Harbourside Redevelopment Modification 3 and Stage 2 - Tower and Podium

Modification of Concept Approval
SSD 7874 MOD 3

State significant development assessment
SSD 49295711

December 2023

Figure 20 | Typical views (left) and proposed views with soil mounding and lift (right) from lower level apartments within ODH facing east (Base source: Applicant’s RtS)

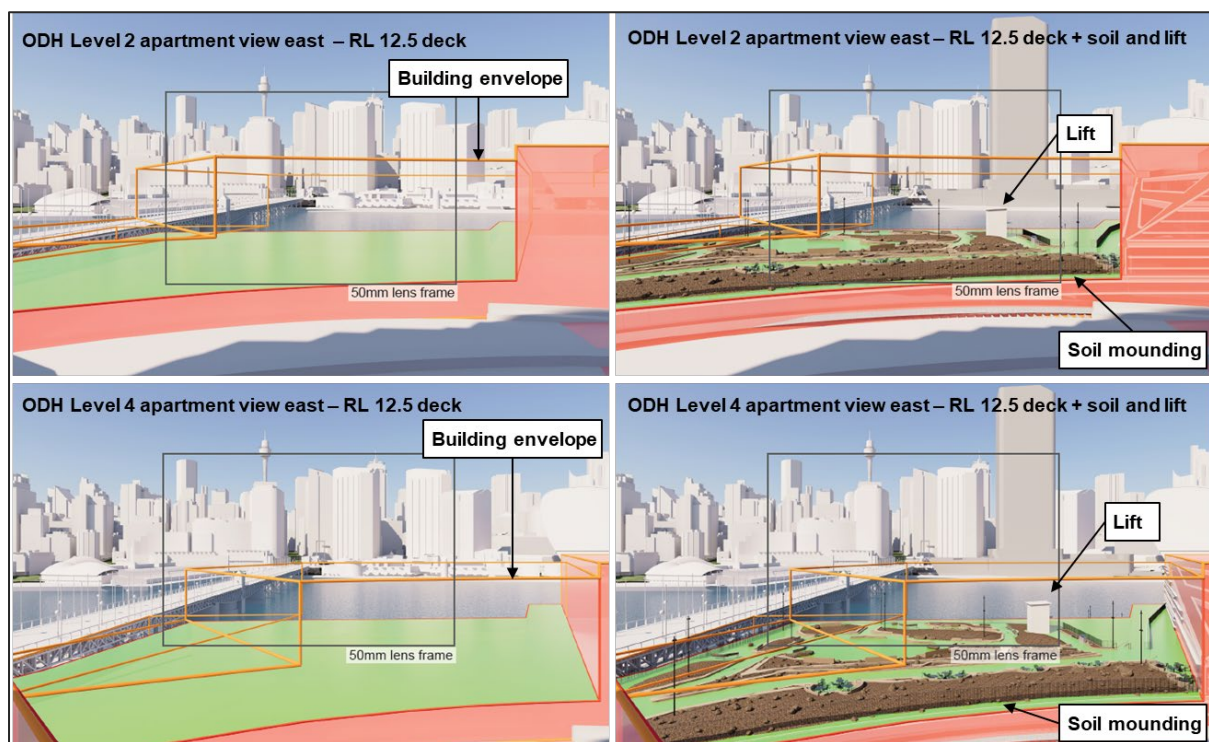
Concerns were raised in public submissions about the proposed protrusions above the deck, in particular:

- soil mounding and associated tree planting would have adverse amenity impacts on ODH (view loss / overshadowing), obscure views to Darling Harbour and Pymont Bridge, block sightlines within the park (i.e. Personal safety / security risk and prevent child supervision) and result in an unusable public open space
- soil mounding and tree planting is inconsistent with condition A16 requirements to demonstrate minimal impact on adjoining residential properties and condition C15(d) which requires the provision of minimum of soil volumes
- soil mounding should not exceed RL 12.5, the maximum soil height should be clarified and tree pits should be built into the podium to accommodate deep soil
- mounding is disproportionately concentrated in the northern podium.

Council raised no objection to the provision of soil mounding on the northern podium. However, it requested clarification of the proposed soil depth, volume and extent of mounding to ensure it is capable of supporting tree planting. In addition, the podium structural slab should make allowances for tree planter set downs or similar alternative(s). SES recommended the Applicant consider the potential impact of mounding on overland flows and the potential to channel flows down the Waterfront Steps. In response, the Applicant noted the detailed design of the Waterfront Garden and public domain (including soil mounding and tree planting) forms part of the separate SSDA3 application, and consideration of safety and accessibility issues relating to the height of mounding do not form part of the current application. Notwithstanding this, the Applicant stated the Waterfront Garden would be designed to ensure the proposed soil mounding will not impact public accessibility, safety or usability of the space.

The Applicant updated the VVIA and stated the proposed mounding and lift would not result in any adverse view loss or sightline impacts. In addition, the podium has been designed to include slab set down areas (Figure 21) and this will allow for a range of soil depths and volumes to be provided within and above the deck level. The Applicant confirmed that the maximum:

- mounding height above the deck would be limited to 800 mm (RL 13.3)
- lift height would be between 3 and 4 metres (subject to detailed design) and be designed to be lightweight, as translucent as possible and would sit well below the canopy level of the future surrounding trees.

Figure 22 | Concept Approval reference scheme (left) SSD proposed through site link (right) Bunn Street through site link (Base source: SSD 7874 and Applicant's EIS)

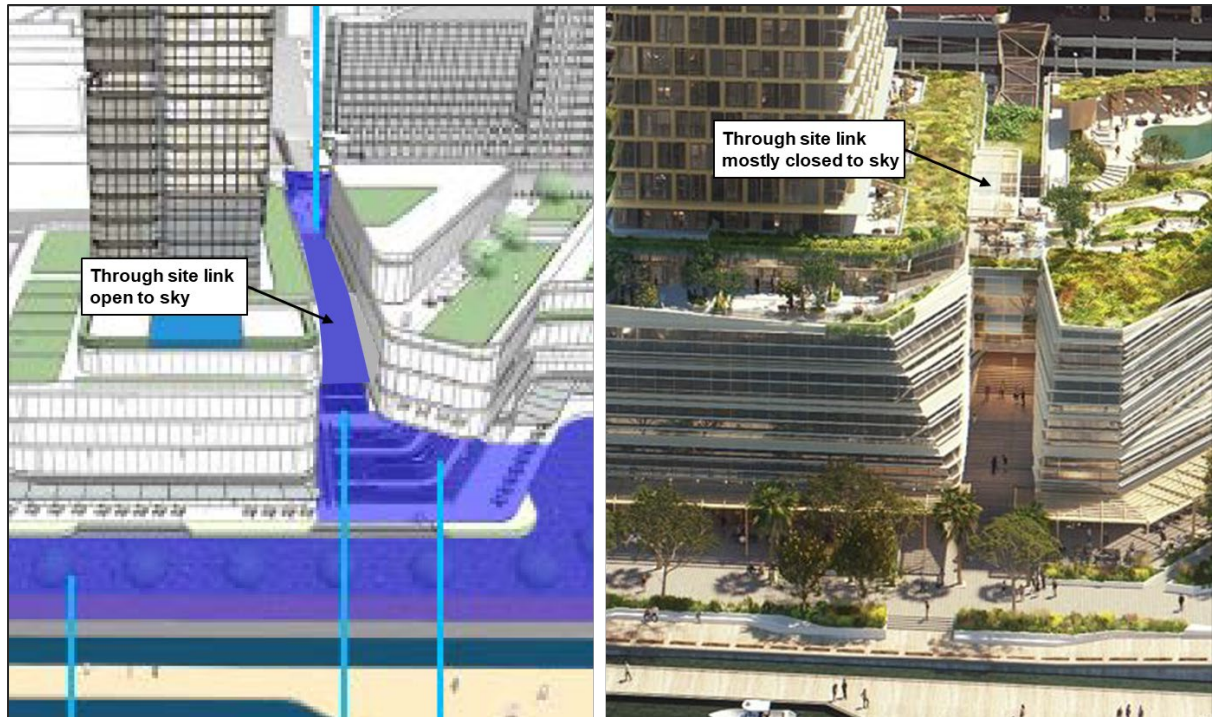
Council stated it does not support the change to the open sky nature of the through site link without restriction. Council recommended any commercial floorplates should be bridged over the link with minimal reduction of sky and provide a minimum 2-3 storey vertical clearance beneath any bridge to preserve openness and civic quality. Council also recommended the link be appropriately activated by the office floors to ensure it is overlooked and provided with sufficient passive surveillance.

Figure 29 | Typical podium corner junction material interface (Source: Council's submission)

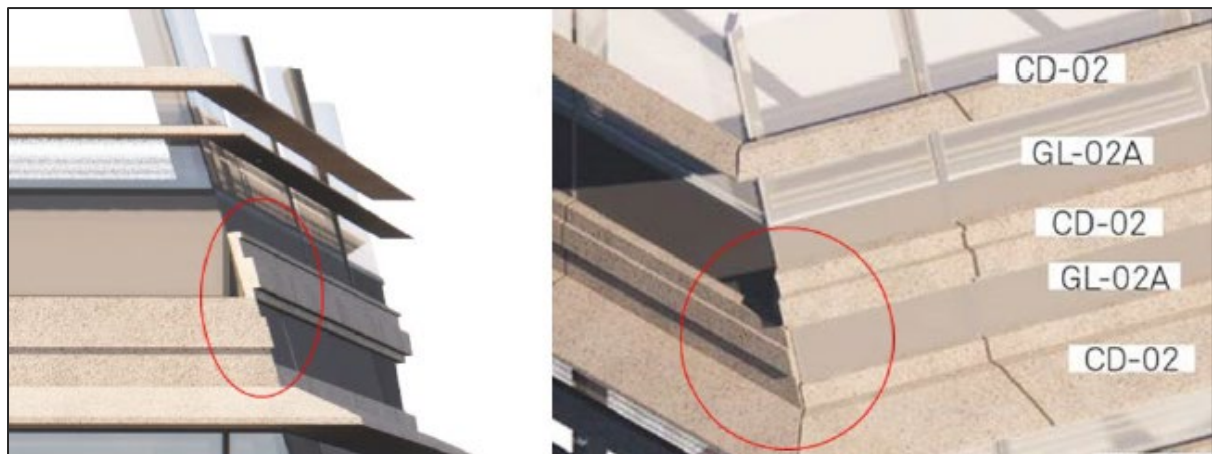
Council raised concern that materials do not wrap around the podium corner junctions and reduce the sculptural quality of the design. Council recommended amendments to avoid the need for a joint at the corners (**Figure 29**). In response, the Applicant confirmed it would not object to a condition requiring the resolution of podium corner junction material treatment prior to the issue of a construction certificate.

The Department considers the proposal presents a unique design that would create a high quality building and achieves design excellence (as discussed in **Section 6.4.1**). In particular, the Department considers the architectural design approach is highly cohesive, and the overall design and appearance of the building comprises a sophisticated architectural composition.

Figure 31 | Shopfront options (top) and locations (bottom) (Base source: Applicant’s RRFI)

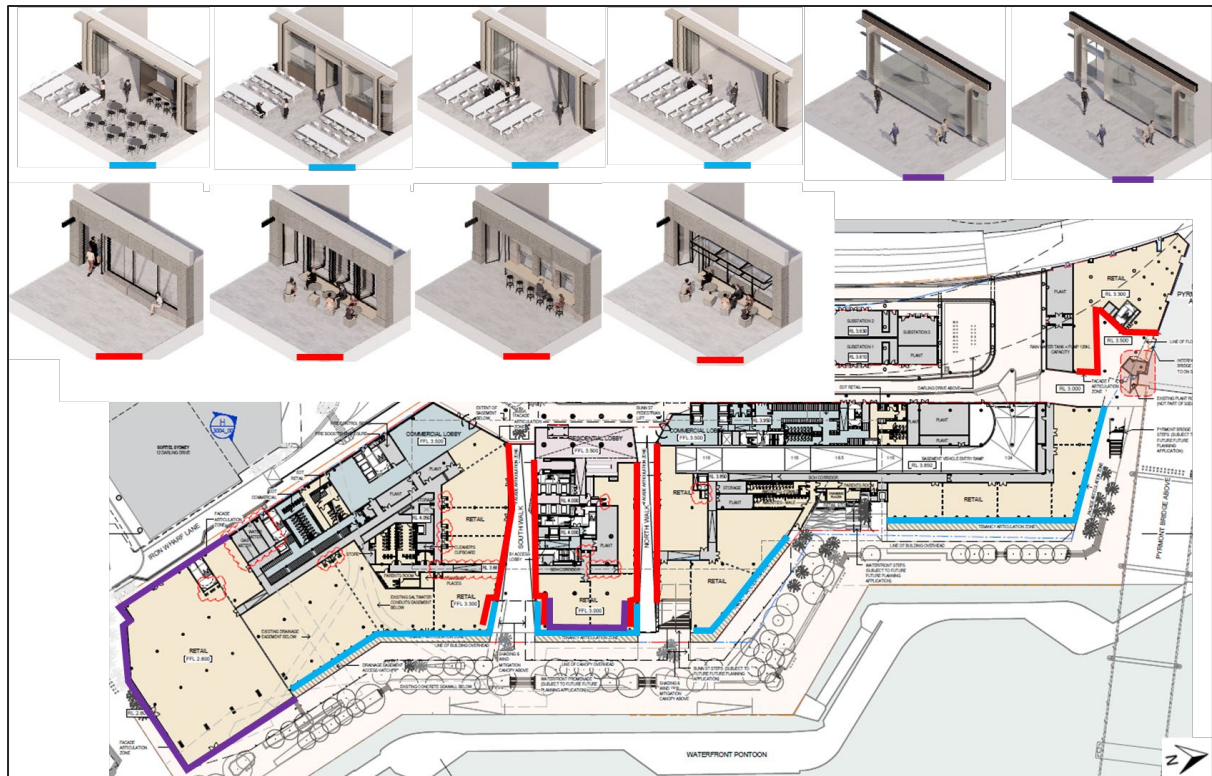
Council recommended that the Applicant provide detailed shopfront designs options and that the Applicant ensure a variety of shopfronts are installed within the podium elevations. The DIP requested the Applicant ensure universal access is provided for each shopfront option.

In response the Applicant provided detailed shopfront designs, confirmed shopfront locations and that the use of a single shopfront design would be limited to no more than 60% of the length of the promenade and 50% of the north and south through site links.

The Department notes that retail fit-out does not form part of this application and the selection (from the options above) and installation of shopfronts would be undertaken by future occupants of the retail units. The Department supports the provision of shopfront kit options as:

Figure 32 | Points where the 24m/s wind safety criteria is exceeded (Base source: Applicant's EIS)

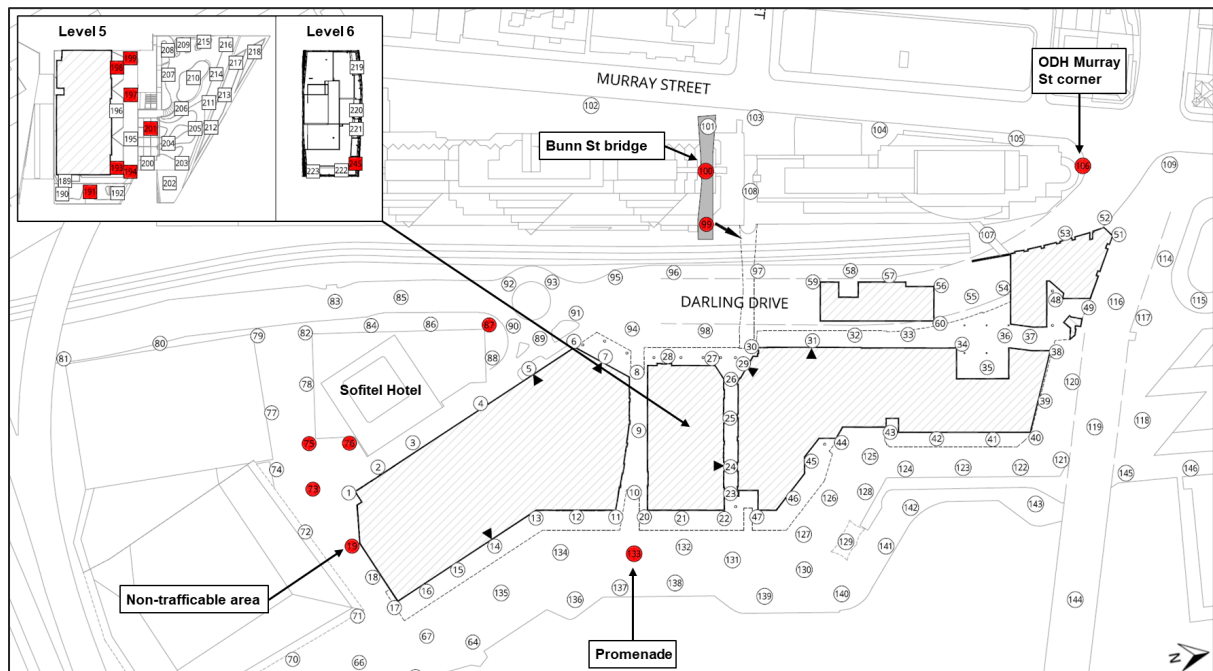
- wind safety exceedances occur at the Level 5 and 6 residential terraces and around the site at the Bunn Street bridge, ODH Murray Street corner, promenade and adjacent to the Sofitel Hotel.

The PWEA recommends mitigation measures including localised physical canopies and screening together with soft landscaping within the residential communal open spaces and the installation of awnings and screens coupled with extensive tree planting within the public domain.

Figure 33 | Wind comfort levels for the development without mitigation (left) within mitigation and established planting (right) (Base source: Applicant's EIS)

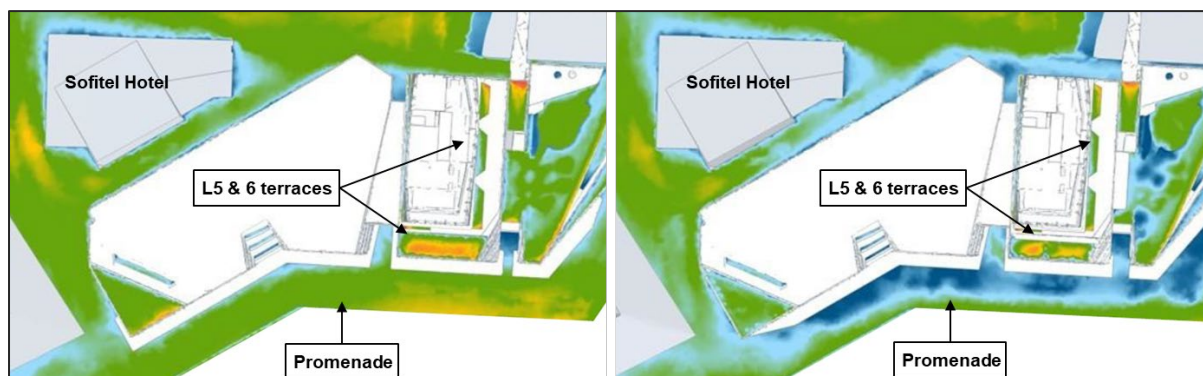
The Applicant updated the PWEA and confirmed the impact on wind mitigation measure on the identified wind impacts (**Figure 33**). In addition, the PWEA confirmed the Level 5 and 6 terraces remain susceptible to discomfort and wind safety issues due to their exposure to prevailing winds. Consequently, the PWEA recommended the design of these spaces be further refined, include additional measures such as corner screening or awning extensions and that further wind tunnel testing being undertaken to ensure additional mitigation measures adequately address wind comfort / safety conditions.

The Department therefore recommends a condition requiring the Applicant further refine the design of the Level 5 and 6 residential terraces and undertake further wind tunnel testing to ensure the wind impacts are reduced as much as possible.

Figure 34 | On-building landscaping locations and types (Base source: Applicant's RtS)

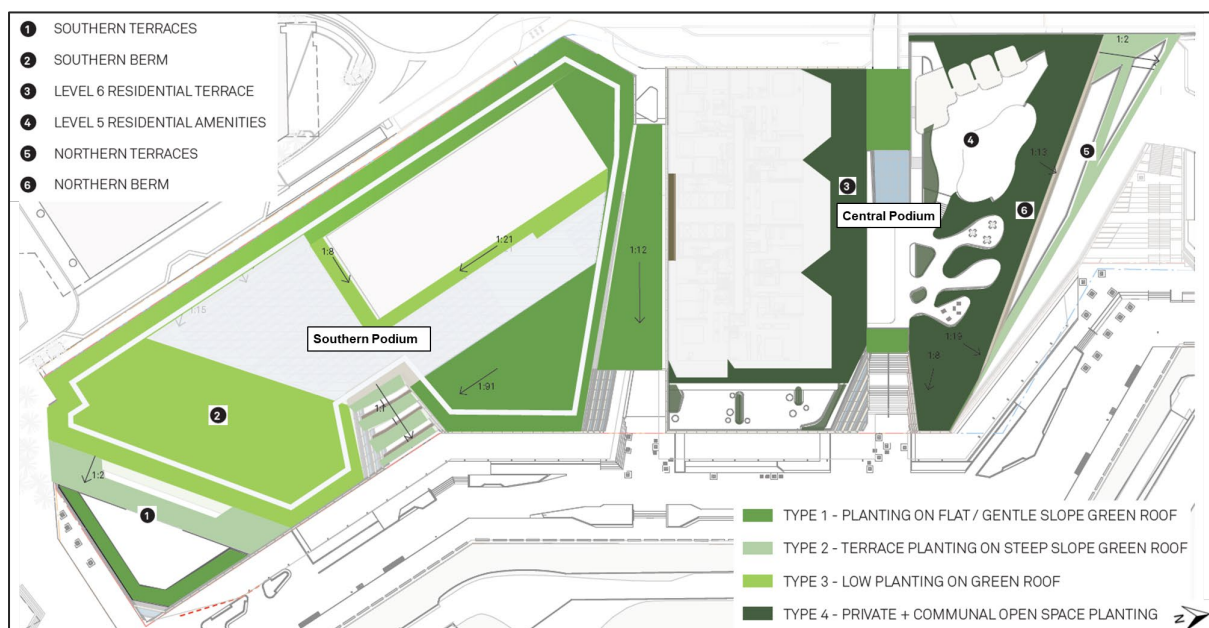
Council did not object to the proposed design and layout of the green roofs, communal and private gardens in principle. However, it initially recommended that additional information be provided on the detailed viability, access, maintenance and soil depths of green roofs, the Level 5 terrace's consistency with the Sydney Landscape Code and safety of planting at penthouse level.
